ADDENDUM 1 DATE: February 11, 2019

Contract 18-C-00036; Madison Street Park

Bidders on the above referenced project are hereby notified that the following addendum is made to the Contract Documents. BIDS TO BE SUBMITTED SHALL CONFORM TO THIS NOTICE.

SHEET

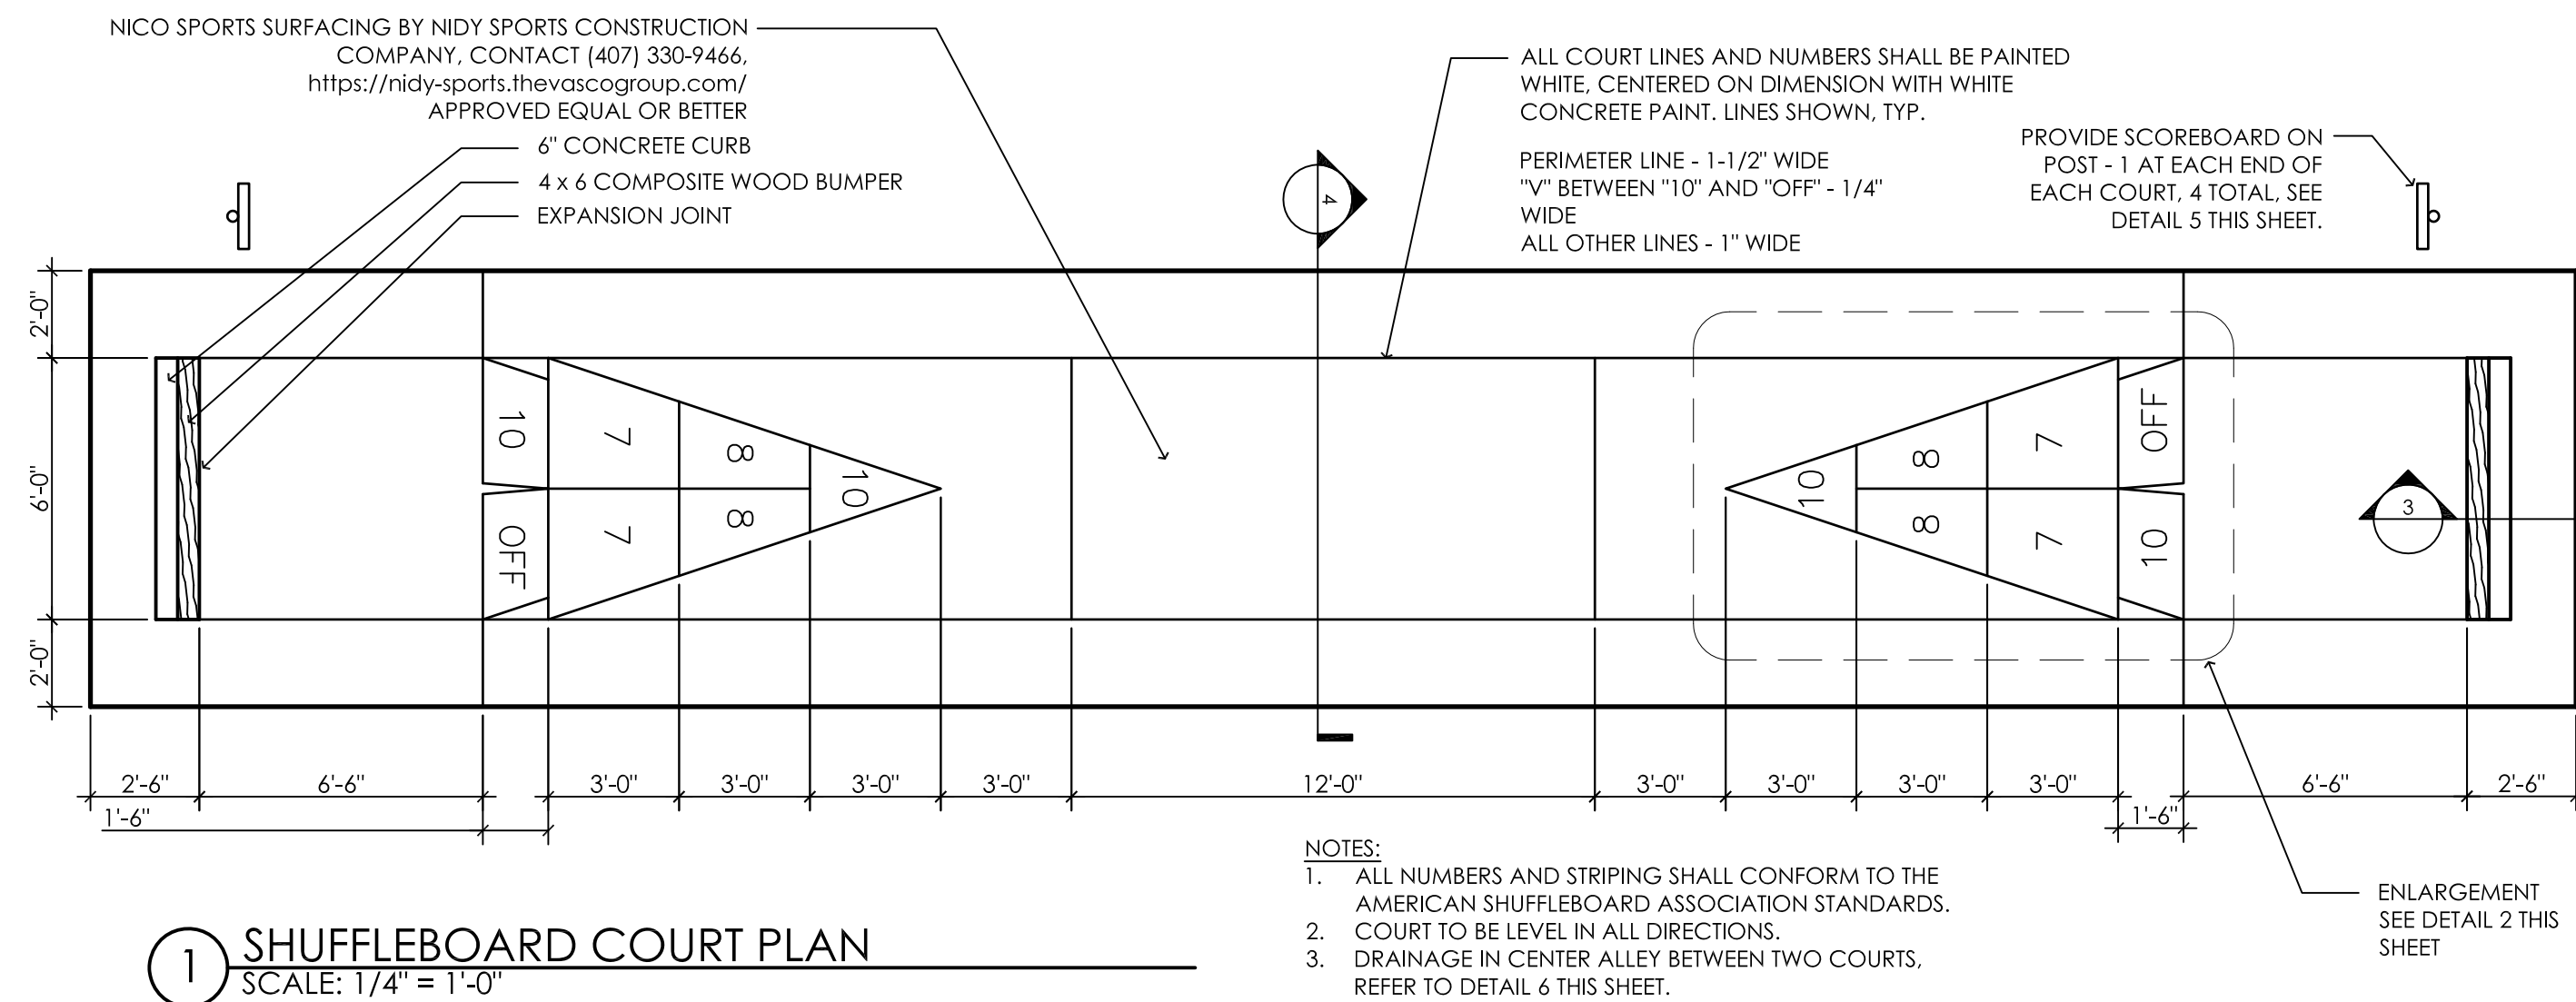
- Item 4: Replace plan Sheet L120 with the attached Sheet L120.
- Item 5: Replace plan Sheet L523 with attached Sheet L523.
- Item 6: Clarification: plan Sheet L522 Hardscape Details, Detail 8 Seat Wall Section: The 4"x4" tiles are to be supplied and installed by the Contractor. Tile detail will be specified by artist, coordinated through the City and payment made under contract pay item no. 9002 Public Art Allowance.
